Product Change Notification

Change Notification #: **116118 - 05**

Change Title: Intel® Server Chassis R1304WTXXX,
Intel® Server Chassis R1208WTXXX,
Intel® Server Chassis R2000WTXXX,
Intel® Server Chassis R2312WTXXX,
Intel® Server System R1208WTTGSR,
Intel® Server System R1208WT2GSR,
Intel® Server System R1304WTTGSR,
Intel® Server System R1304WT2GSR,
Intel® Server System R2208WT2YSR,
Intel® Server System R2208WTTYSR,
Intel® Server System R2208WTTYC1R,
Intel® Server System R2308WTTYSR,
Intel® Server System R2224WTTYSR,
Intel® Server System R2312WTTYSR,
**PCN 116118-05, Product Design, Order Code,
Rear panel and rear brackets new design,**

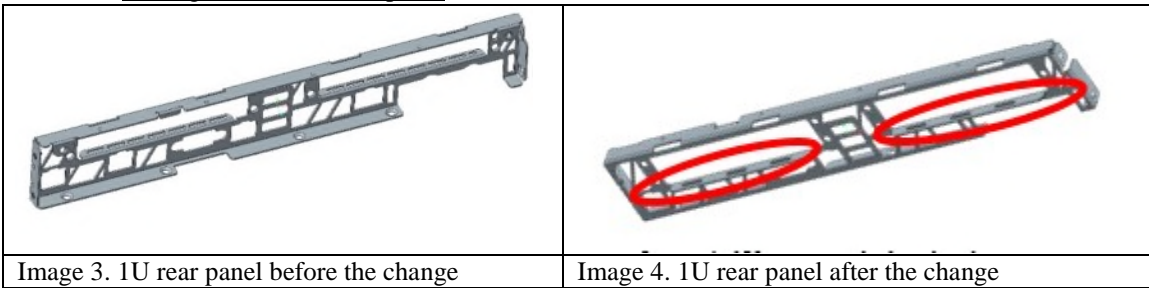
1. Change the design of the left rear bracket

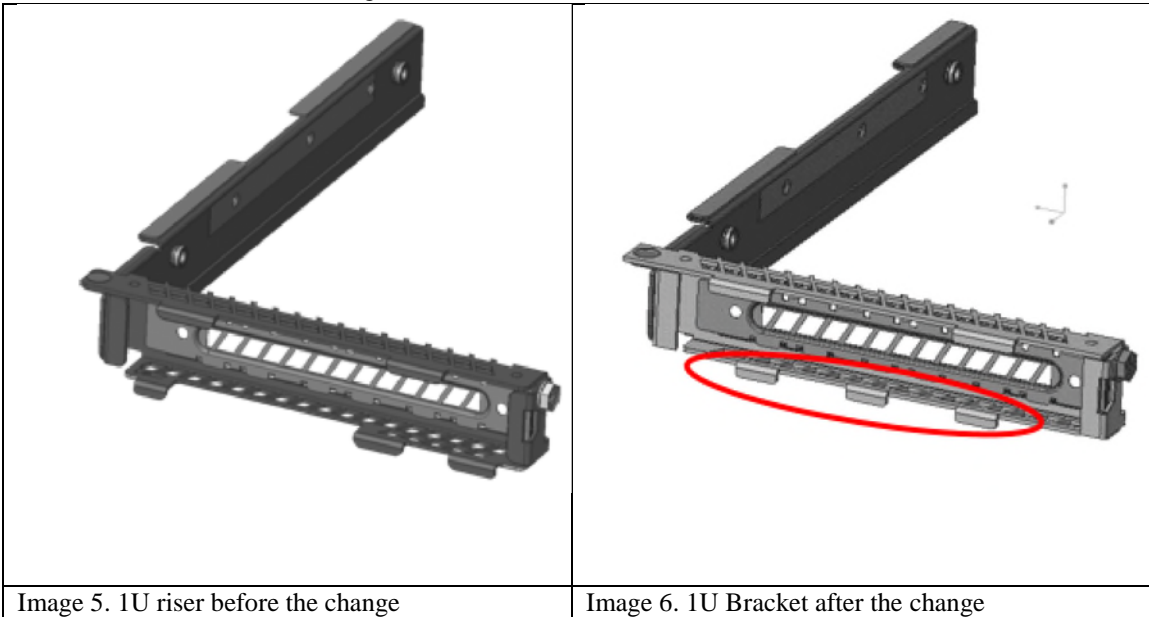
2. Adding holes to the rear panel

Image 7. Rear Panel before the change

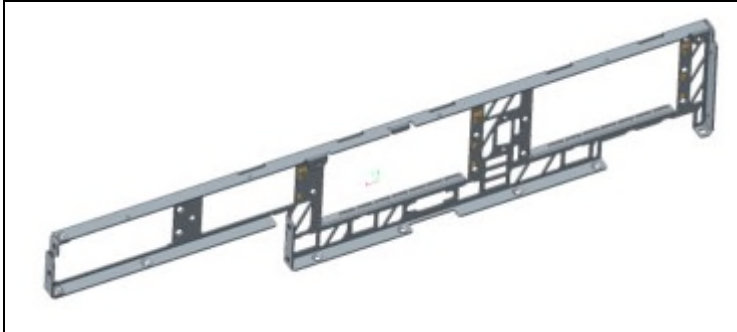
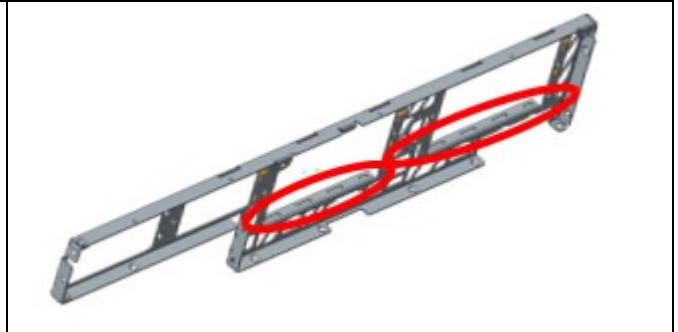
1. Adding holes to the rear panel.

Image 9. Rear center bracket before the change

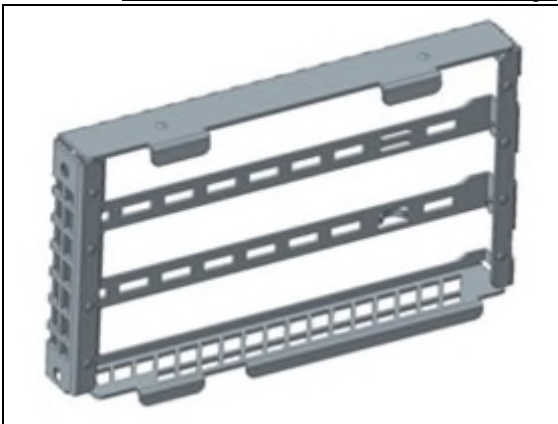
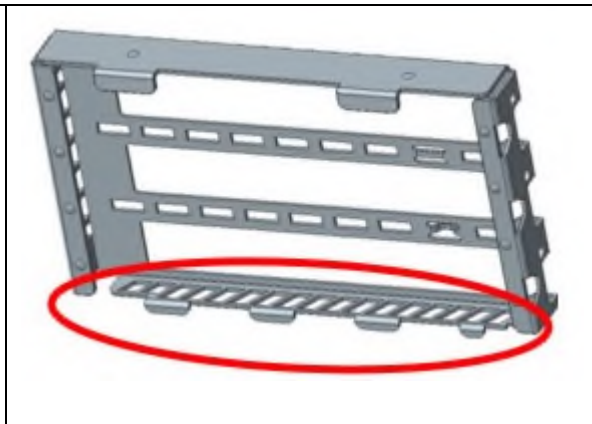
2. The center rear bracket has a new design

Image 11. Bracket before the change

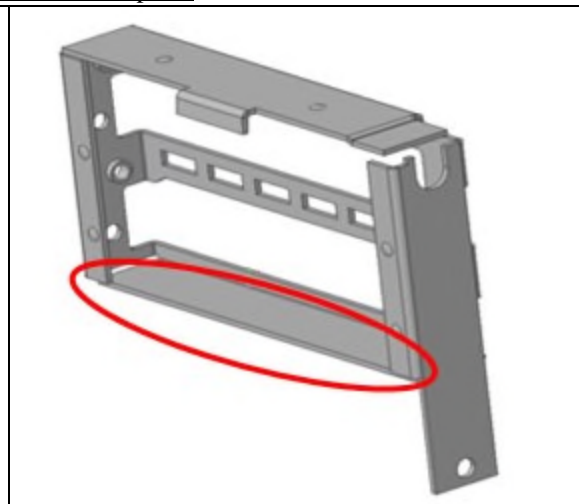
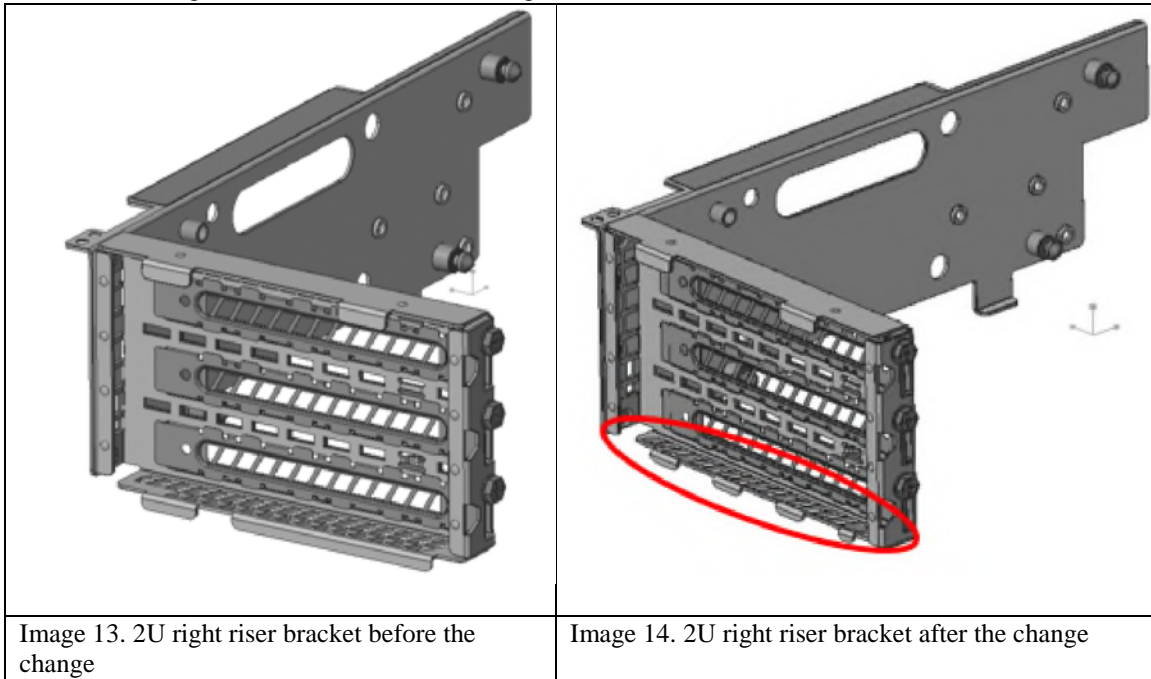
3. Remove the stopper of the left rear bracket on the rear panel

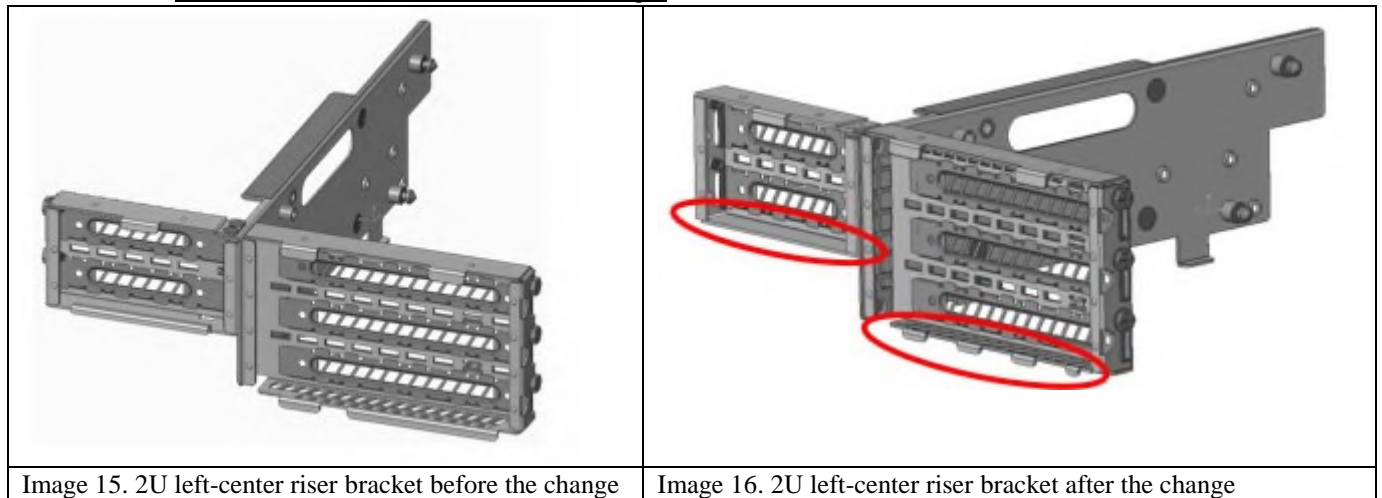
4. The right riser bracket has a new design.
